JRPP No:	2010SYE078
DA No:	DA358/10
PROPOSED DEVELOPMENT	Demolition of part of existing structures including three dwellings and construction of a new dwelling over 4 levels including basement garage with car lift, inclinator and landscaping. 16 – 20 Lodge Road Cremorne
APPLICANT:	Leda Holdings Pty Ltd
REPORT BY:	Geoff Mossemeneer, Executive Planner, North Sydney Council

Assessment Report and Recommendation

VIEW 5: EXISTING

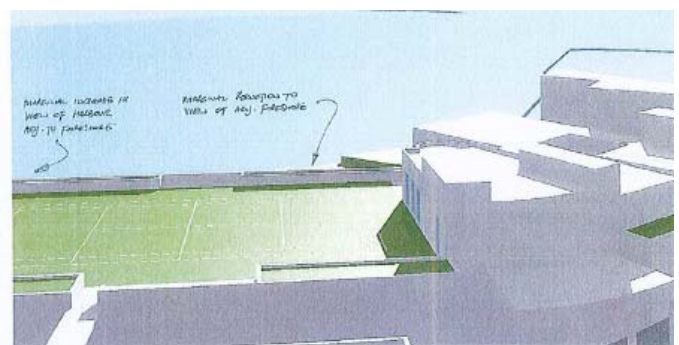
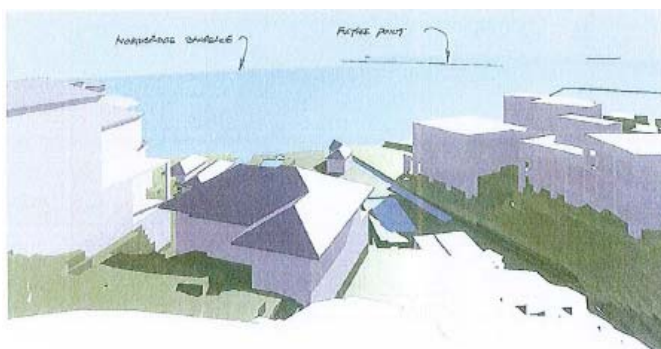
Both terraces enjoy a water view in which the interface between land and water is visible that is generally considered to be a more valuable view. The views are also from the main living areas of the dwelling. Of additional interest is the activity on the foreshore at

It would appear that these areas can be modified by removal, reducing the height or setting back further from the foreshore. The area around the canal and jetty is the important part of the view to be shared. It would be unreasonable to expect the whole of the foreshore to be visible. The tennis court is elevated where Council's controls prefer it at ground level. The entertainment area on that level is well over the height control and adds bulk to the building. This area should be removed. The northern edge of the building (or at least the eastern end needs to be reconsidered. A height breach would only be acceptable if view sharing was achieved.

VIEW 2: EXISTING

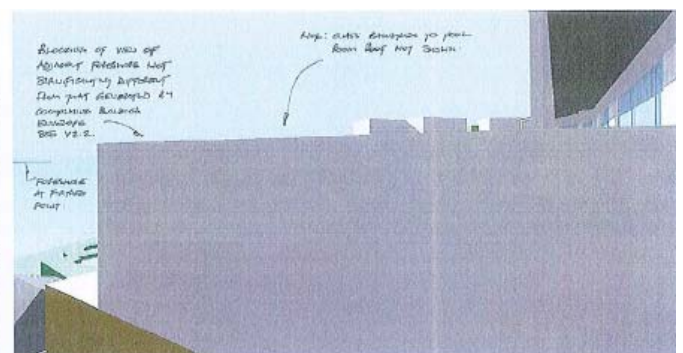
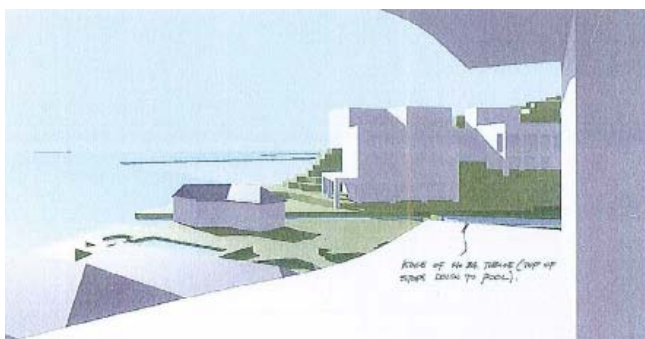
The view is of the foreshore and numerous jetties and moorings up to the opening to the Bay. There is often activity along the foreshore and it is an important part of the overall vista enjoyed from both terraces.

It is evident that the views will be obstructed with the new dwelling. My opinion is that the impact could be classified as moderate if caused by a compliant development. The parts of the building that causes the obstruction is the western edge of spa room (breach of 4.95) and the western edge of tennis court/planter box (breach at southern end is 4.86m). I conclude the impact to be severe.

It would appear that these areas can be modified by removal, reducing the height or setting back further from the foreshore and side boundary. The spa and internal pool area need to be relocated and the north west corner of the tennis court/planter needs to be setback several metres to the south and east to maintain the view of the foreshore from within the living area of No.14 Lodge Road. A building height plane breach would only be acceptable if view sharing was achieved.
